Item Name: Crosstube Turning Detaill

DART AEROSPACE LTD		Work Order: 107457
Description: Crosstube Assembly (206L High Fwd)		Part Number: D206-667-143
Inspection Dwg: D206-667-143 Rev: C		Page 1 of 2

DRAWING NO. D206-667-143	TITLE CROSSTUBE ASS'Y (206L HIGH FWD)	REV. C	DART AEROSPACE LTD ENGINEERING ORDER		D.E.O. NO. D206-667-143-C-1	SHEET NO. SHEET 1 OF 1	SCALE NTS
DRAWN 92	CHECKED ASS	MFG. APPR. [Signature]	APPROVED MD		DE APPR. [Signature]		
DATE 11.07.15	DATE 11.07.20	DATE 11.07.21	DATE 11/07/21		DATE 11.07.21

DRAWING NO. D206-667-143	TITLE CROSSTUBE ASS'Y (206L HIGH FWD)	REV. C	DART AEROSPACE LTD ENGINEERING ORDER		D.E.O. NO. D206-667-143-C-2	SHEET NO. SHEET 1 OF 1	SCALE NTS
DRAWN AJM	CHECKED	MFG. APPR.	APPROVED		DE APPR.		
DATE 12.08.02	DATE 12.08.02	DATE 12.08.02	DATE 12.08.02		DATE 12-08-02

DETAIL P
BONDING STRAP INSTALLATION 2 PL

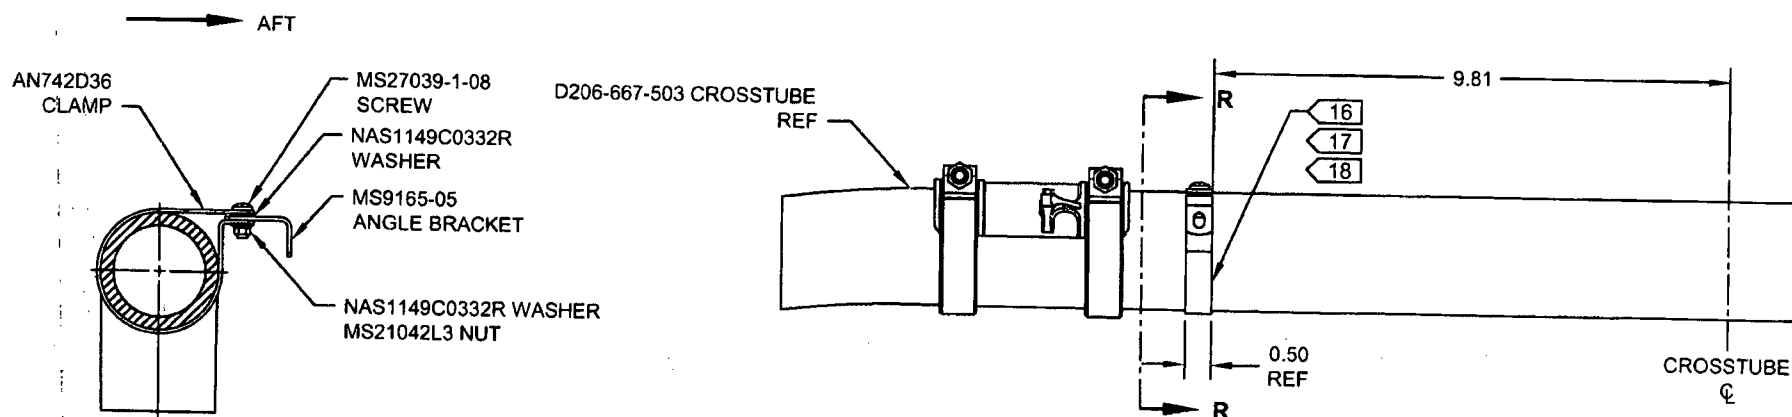
ADD ELECTRICAL GROUNDING STRAP

ITEM	QTY -143	PART NUMBER	DESCRIPTION
1	X	D206-667-143	CROSSTUBE ASSEMBLY (206L HIGH FWD)
10	2	AN742D36	CLAMP
11	2	MS9165-05	ANGLE BRACKET
12	2	MS21042L3	NUT (OR MS21042-3)
13	2	MS27039-1-08	SCREW
14	4	NAS1149C0332R	WASHER (OR AN960C10L)

- 16) MASK AREA UNDER CLAMP PRIOR TO PAINTING
- 17) SEAL EDGES WHERE AN742D36 CLAMP MEETS WITH THE CROSSTUBE USING SIKAFLEX-241/-291 OR MIL-S-8802 CLASS B2 OR PROSEAL 890 SEALANT
- 18) PERFORM RESISTANCE CHECK TO ENSURE MAX RESISTANCE IS 10 MILLIOHMS
